YANKEE ATOMIC ELECTRIC COMPANY

Subject: Reactor Vessel Overpressurization

RESPONSE TO NRC QUESTIONS REGARDING
THE YANKEE ROWE SUBMITTAL ON REACTOR VESSEL OVERPRESSURIZATION

DWG NO. III. 17. 1

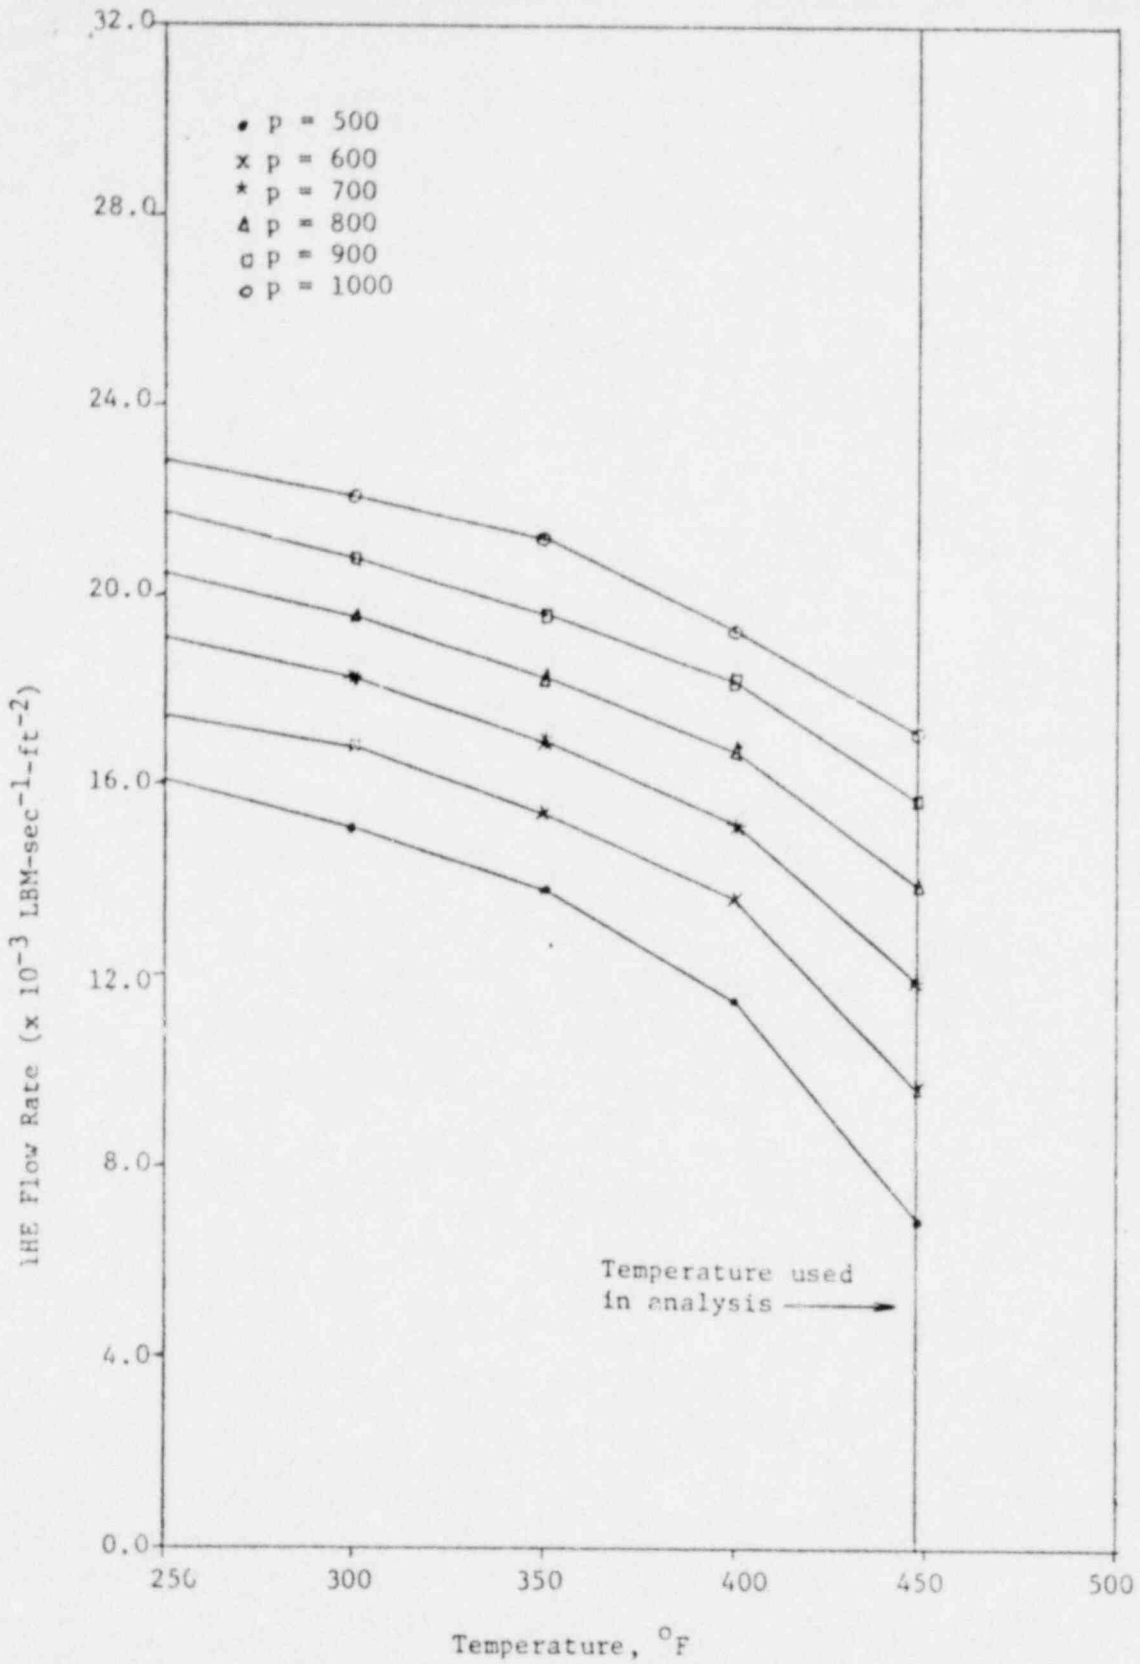
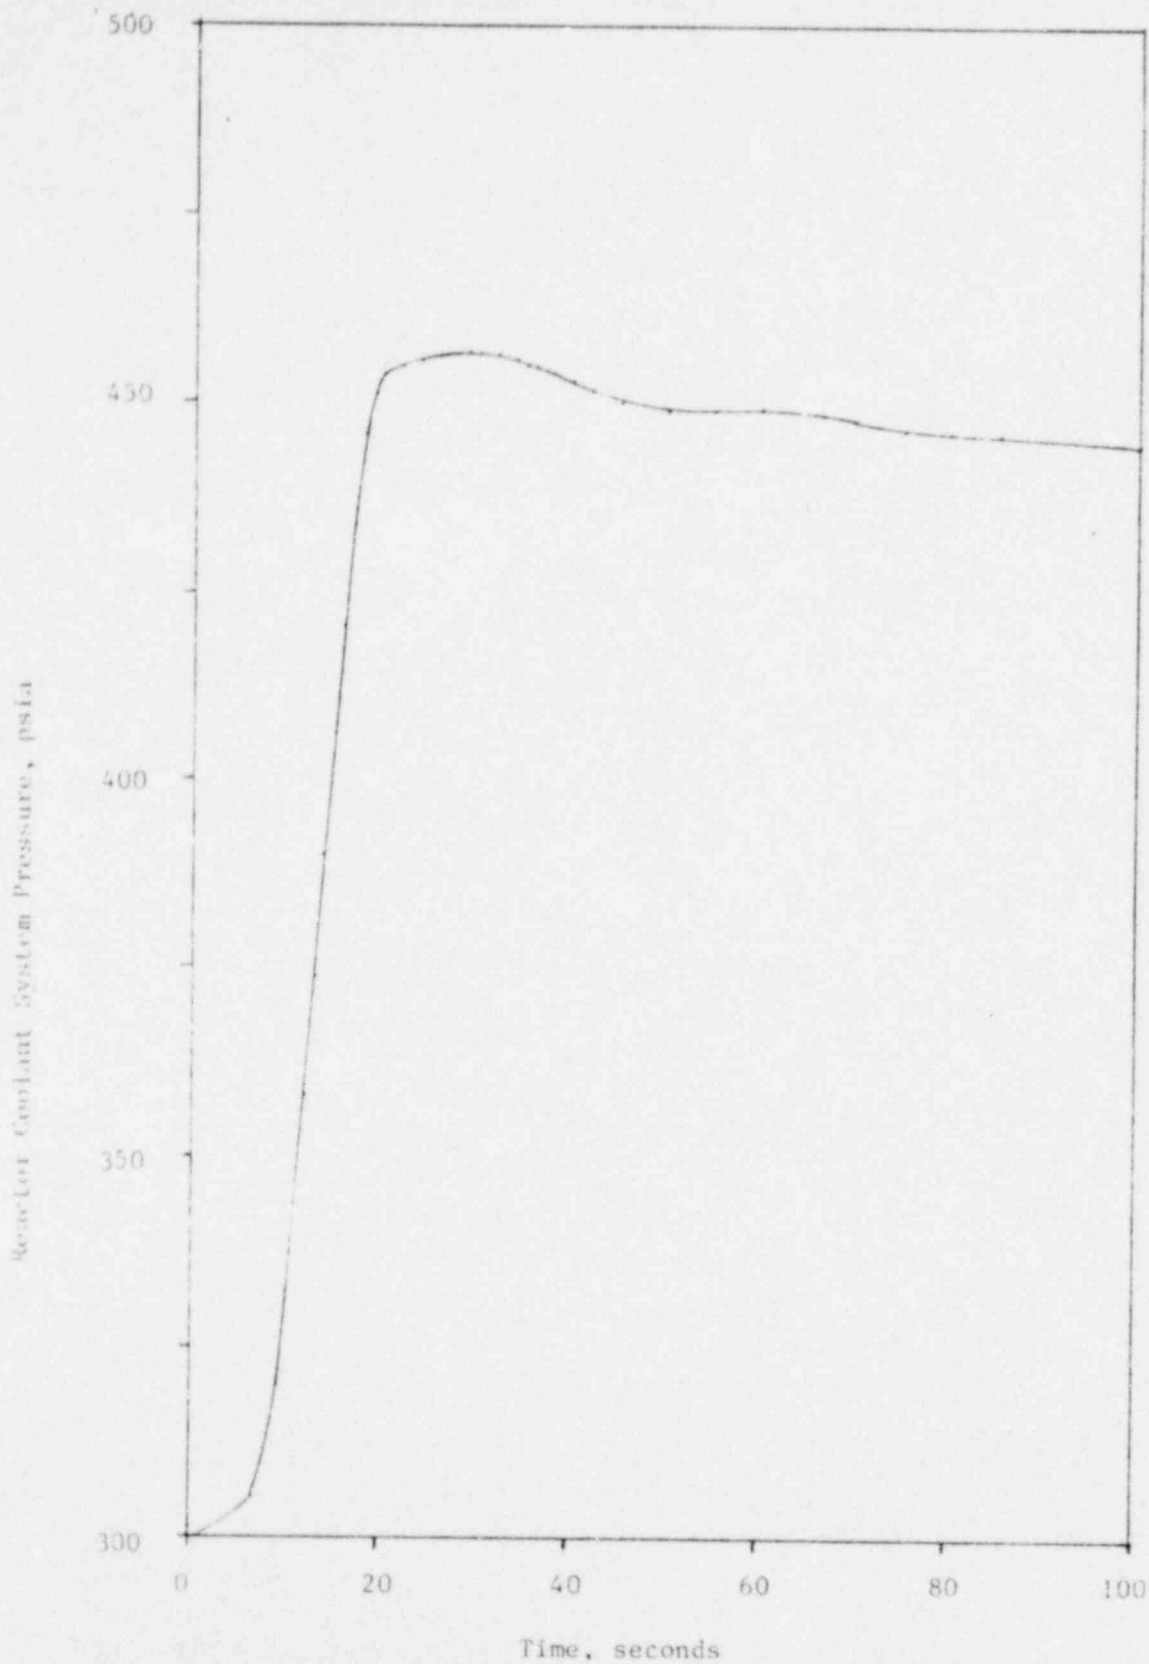
- a. What K_D are you using?
- b. Appendix XI to ASME Section VIII gives capacity conversions for safety valves. Do your relief valves qualify for using Figure UA-231 to determine liquid flow rate? How does the value from this figure compare with your computed values? Discuss any differences.
- c. You state that assuming a saturated condition in the pressurizer yields a conservative relief valve flow rate. Please justify this statement by providing a table of flow rates with corresponding critical pressures, for a number of subcooled and saturated inlet conditions.

- c) Figures III.17.1 and III.17.2 provide the critical pressure ratios and discharge capacities for a number of situations. Also included is a specification of the values used in our analyses which shows the conservative approach taken.
- d) To obtain the flow rates provided in Figure A-1 from the Isentropic Homogeneous Expansion formulation provided on page C-20 (i.e. $\dot{m} = 0.9 \cdot K_D \cdot \dot{m}_c$). The following procedure is used:
